Parsons Down Partnership - 1FE Feasibility Report for West Berkshire Council

Quattro Design Architects have been appointed to conduct a feasibility study for West Berkshire Council to explore how the Parsons Down Partnership Junior and Infants sites could be consolidated/ rationalised further into one 1FE school building but with reserved areas for future 2FE building extensions and external areas. This study follows from the previous 2FE Feasibility Report, conducted by Quattro Design Architects in February 2019, which is attached in Appendix 2.2

Quattro Design Architects were advised in September 2019 that the original Project was to be postponed. Subsequently a new brief for the rationalisation of Parsons Down Schools to a 1FE School was issued to Quattro Design Architects on 20th April 2020. This version of the Feasibility Report (Rev B) acts as a summary update to reflect the revised Project Briefing document; refer to Appendix 2.1

Proposed 1FE GF Plan with Future
2FE Extension - Option 1

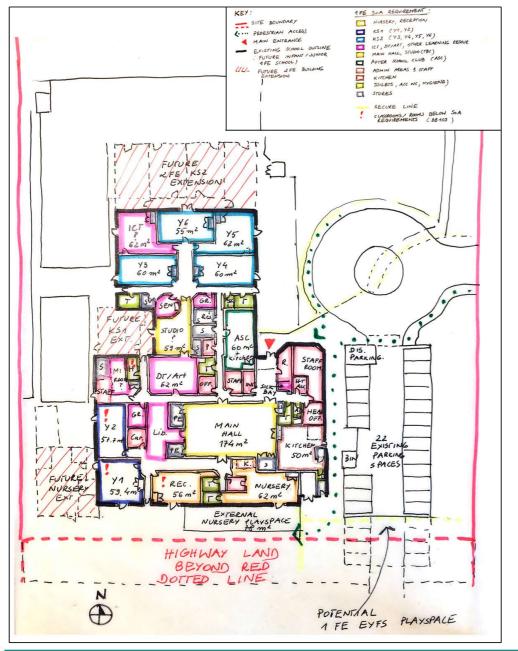
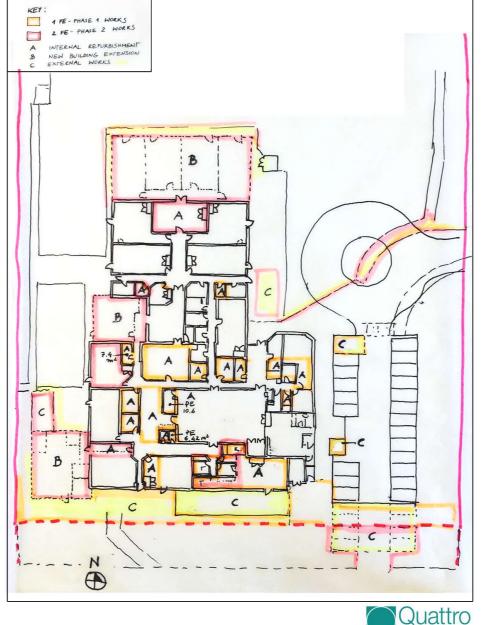
- Using Highways land for 1FE not preferred (longer programme)
- Time-frame for transferring is unknown if Highways land is included (6 months or more)- bigger risk to the project.
- Highways land appropriation might not be accepted or equal amount of land in return might be requested.
- No indication from the School whether they would like the use of the Highways land following the reduction of the scheme from 2FE to 1FE.
- Floor plan Option 1 to be presented to the School for feedback

3.1 Early Considerations - Option 2

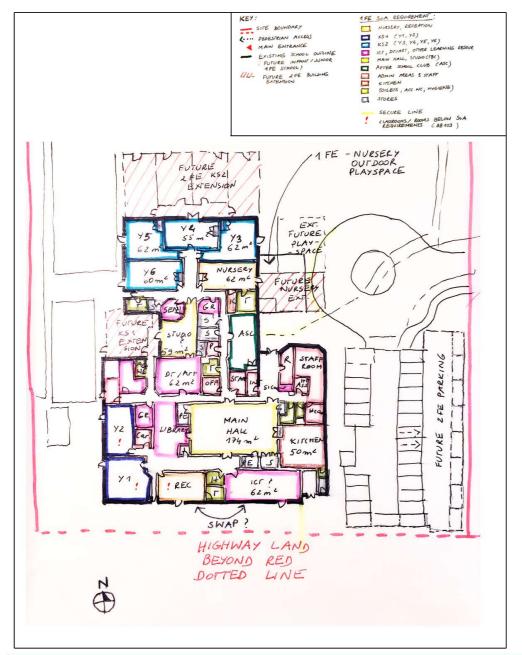
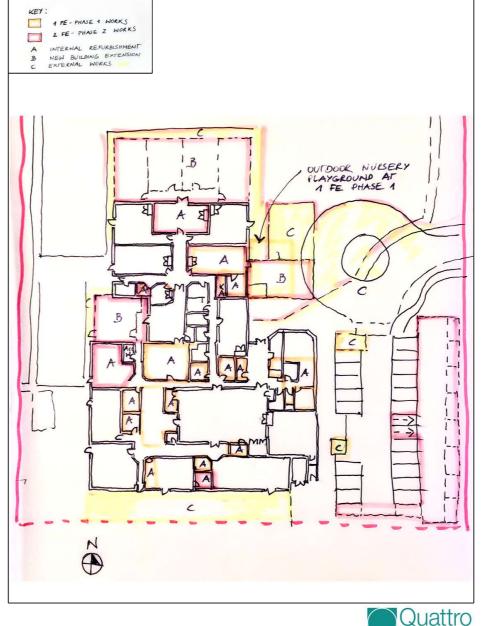
- Not using Highways land for 1FE preferred option
- Risk of time-frame for transferring and acceptance of land appropriation omitted.
- The external areas will need to be able to accommodate the school if expanded to 2FE in the future
- Less disposal land for future housing as this will be reserved for future 2FE external areas
- Future parallel parking for 8 cars will be expensive as the retaining wall would have to be created for the neighbouring housing
- Floor plan Option 2 to be presented to the School for feedback

3.1 Early Considerations- Site Wide Analysis for Option 1

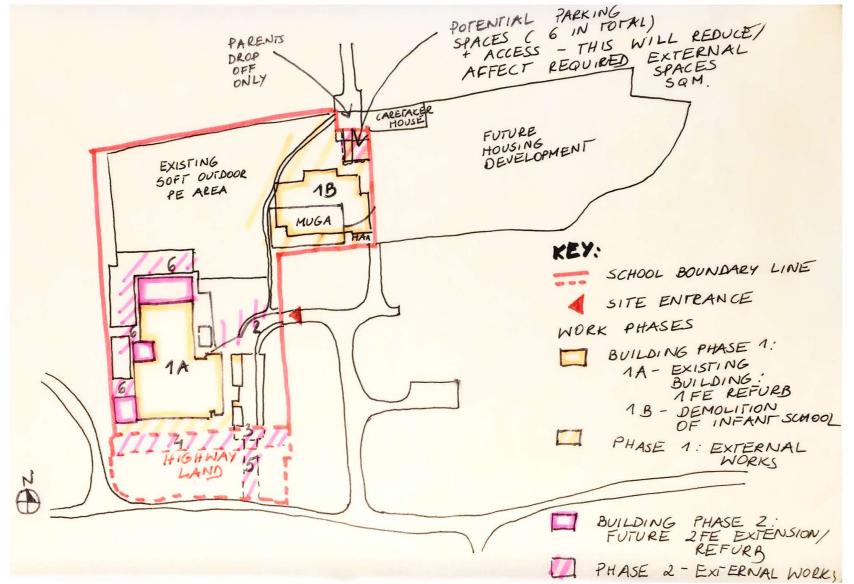
- MUGA at 1FE to be confirmed by QDA (not required)
- Clarification on 'MUGA' understanding to be confirmed by West Berkshire
- If MUGA is required than it needs to be moved outside of existing Infant School footprint to allow this to be built during the refurbishment
- Future car parking expansion preferably to be located at the existing car park, by the Caretaker's House access road to reduce costs and increased.

3.1 Early Considerations - Further Site Wide Analysis Options

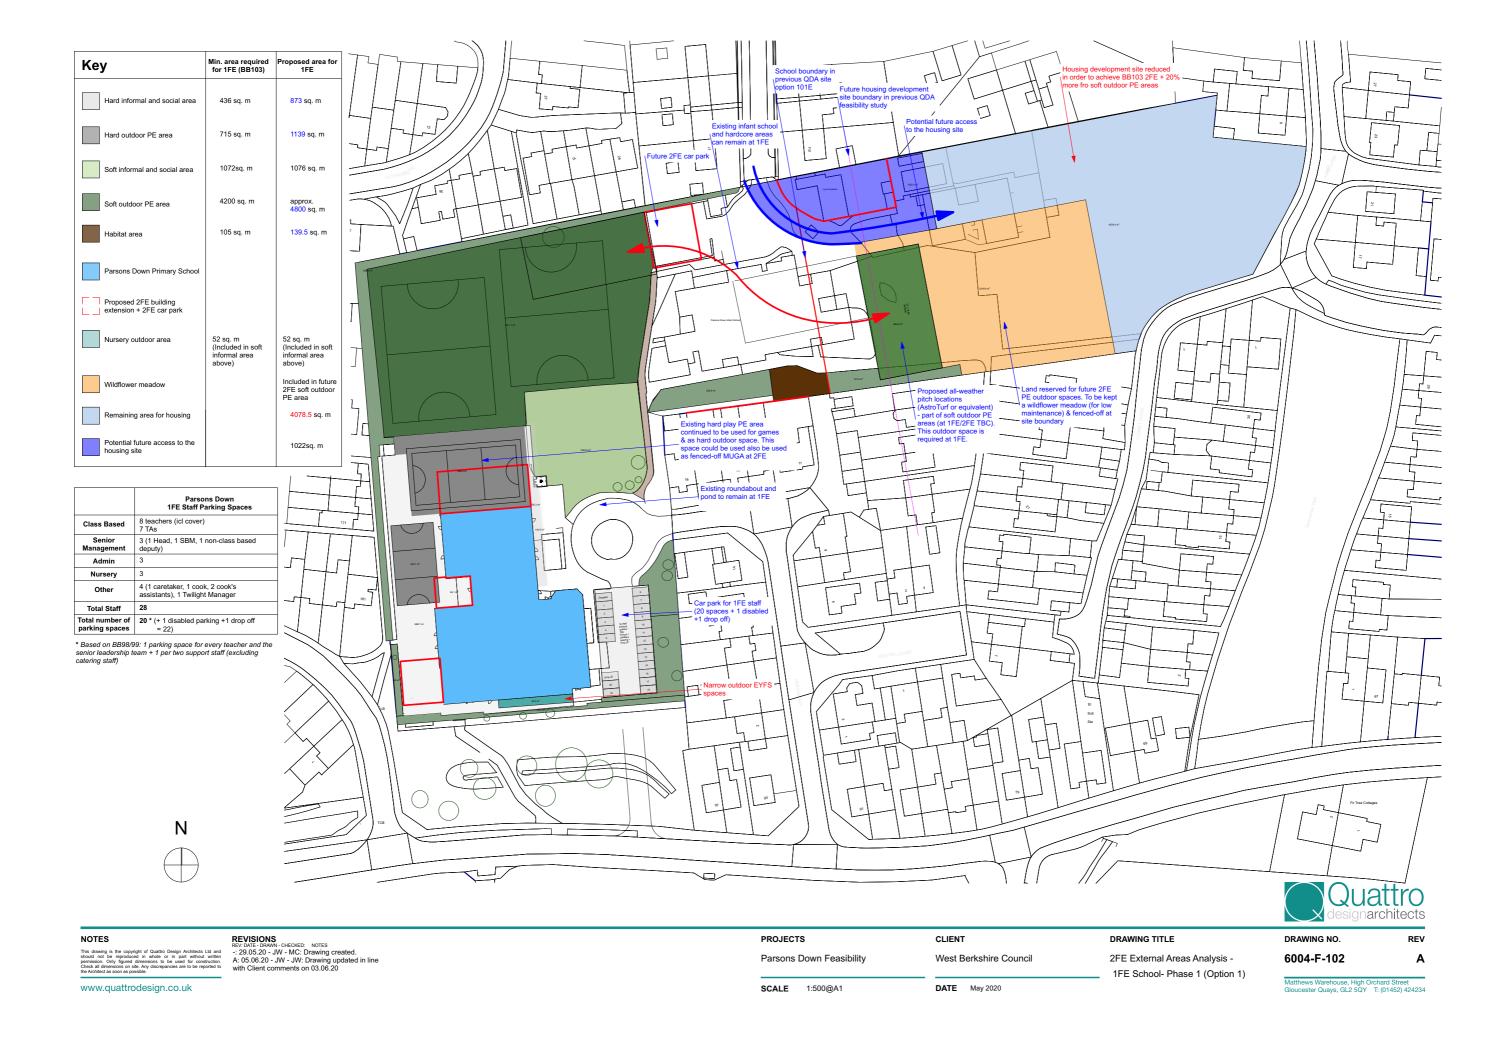
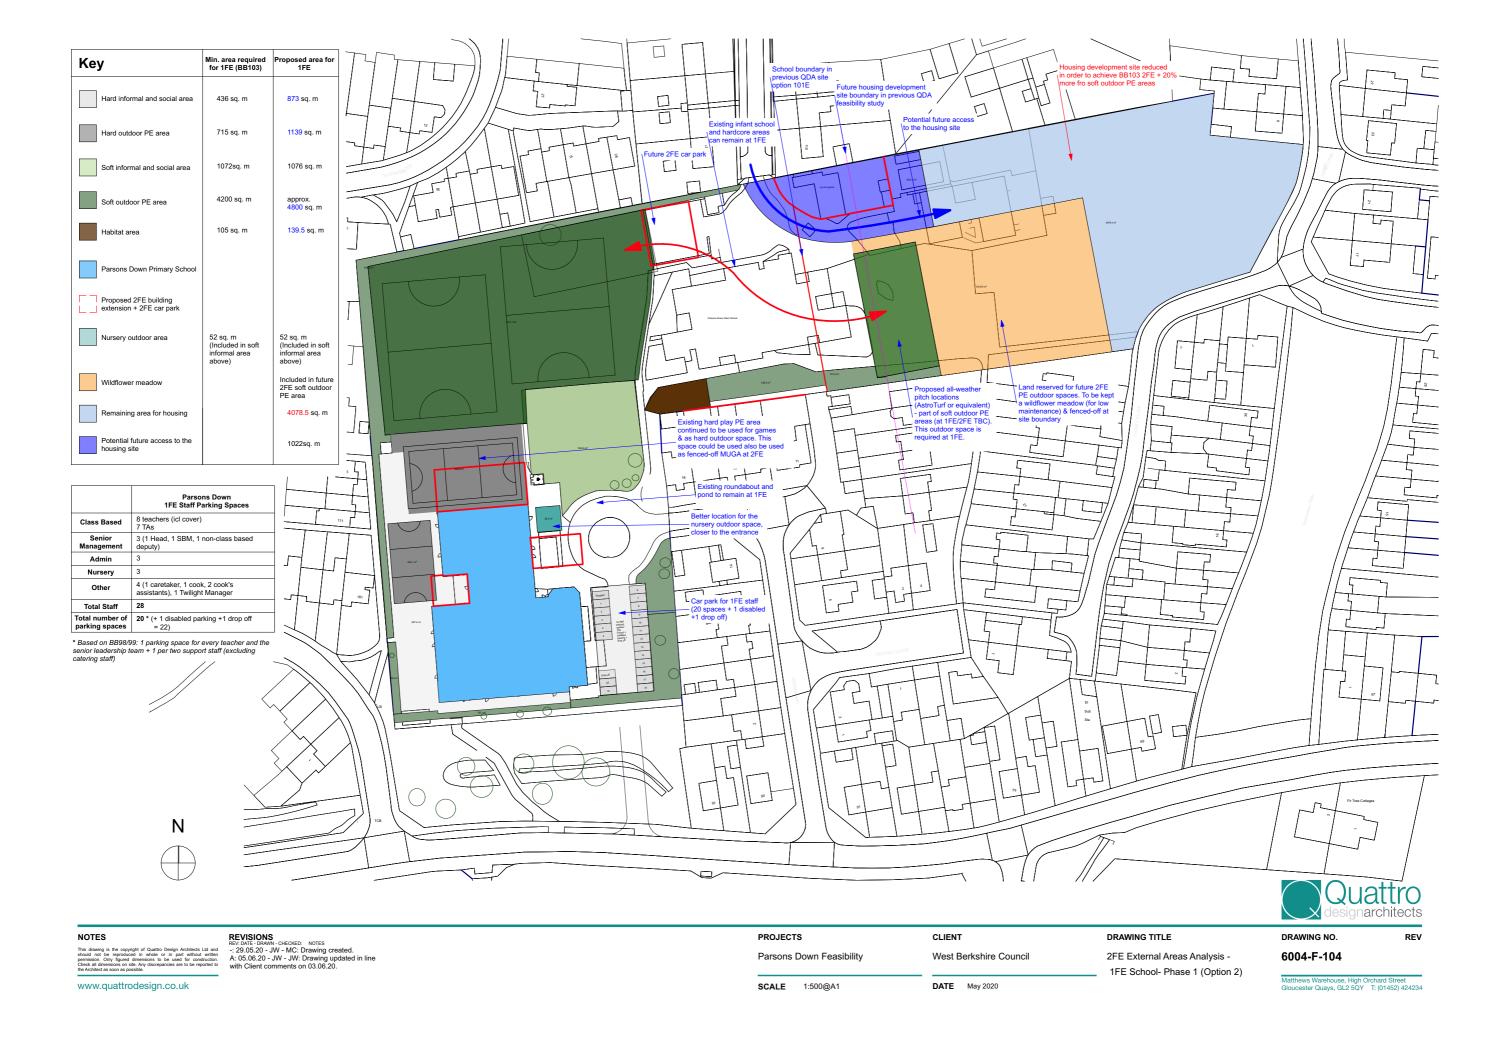
- The existing roundabout and the pond preferably not to be demolished at Phase 1 as 2FE external areas will only be required at 2FE stage.
- Further clarification on additional 'soft PE sports pitch' requested.

- The existing car park is shown as two red squares but not annotated. It is assumed the land required by the School to expand to 2FE will not be hoarded off as 'waste land' but will instead be laid to grass with the new School fence on the boundary. This will give a surplus of grass (soft play) and the car park could therefore be retained to provide additional parking.

- The land at the end of the existing access road by the caretakers house may have more value
 / use than the sliver currently shown at the boundary with the new housing development as two
 or three sites accessed directly from the existing road plus potentially the caretakers house in
 the distant future could be created, so it may be worth showing this as the surplus FFE2 land
 in the Feasibility/Master Plan Agreed. This land could be kept as shared access to any housing

development and the northern school car park for 2FE. There is also the potential option of constructing an all-weather pitch (AstroTurf equivalent) which could be counted twice for the outdoor soft P.E. area helping the site achieve a comfortable 2FE size. It will also potentially reduce the impact on the development land, it will allow more flexibility in the planned layout of the site, a great USP for the school who could also let out this space after school hours to generate an income from it.

• The 2FE soft play area is correct at 8400m2 which is the minimum 2FE site. However, it will be important to aim for at least 20% more area to allow for any future development.

- The existing roundabout and the pond demolition excluded at 1FE Phase 1 and shown at 2FE Phase 2 instead.
- MUGA clarified as an all weather-pitch (AstroTurf equivalent), which could be added at eithe 1FE or 2FE stage and counted as part of additional 2FE soft outdoor spaces and updated or 102A-105A drawings. This pitch was also moved away from the infant school footprint so it can be built before the school demolition. Proposed locations indicated on the plans.

- 2FE car park annotation added to the left red square, right red square has been omitted as it
 is not required. This whole area, together with the infant school surrounds kept as the existing
 tarmac/ hardcore area at 1FE stage.

- The land required by the School to expand to 2FE shown as a wild meadow to reduce the maintenance cost.
- Potential future access to the housing site indicated on the plans in darker blue.

- AstroTurf pitch shown in various locations on plans, away from the infant school footprint.
- Additional 20% more areas (approx. 10080m2) added to 2FE PE area. AstroTurf pitch counted twice for this purpose. No float or embankment added at this stage between the school and the housing sites.
